# Certificate of Appropriateness—Amended

1016 - 1028 E. BRADY ST.      Brady Street Historic District

5/12/2017   Amended 8/9/17   PTS ID   114229   COA: storefront rehabilitation   CCF #161632

PLAN VIEW OF RENOVATED FACADE

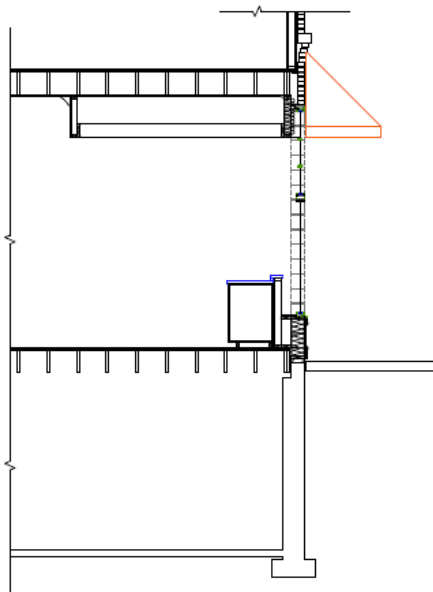
1. Both facades: install a modern storefront system from Tubelite (Versatherm 4500) in both facades. The system is intended to be a loose replica of what was present on the original Mediterranean building with a reconstructed bulkhead, divided lite transom, and standing seam metal awnings in copper or PAC Clad copper color at applicant's discretion.

2. Mediterranean facade: bulkhead will be a glazed thin brick, all glass will be clear, apartment entry door will feature a fanlight/sunburst transom.

3. Germanic facade: main storefront glass will be clear glass, with transom as spandrel glass. Door to upper level may be clear or spandrel at applicant's or Wisconsin Historical Society's discretion, bulkhead will feature recessed panels in natural wood, painted to color of applicant's or Wisconsin Historical Society's discretion.

**3. All work to be done per attached elevation drawing, except as noted above.**
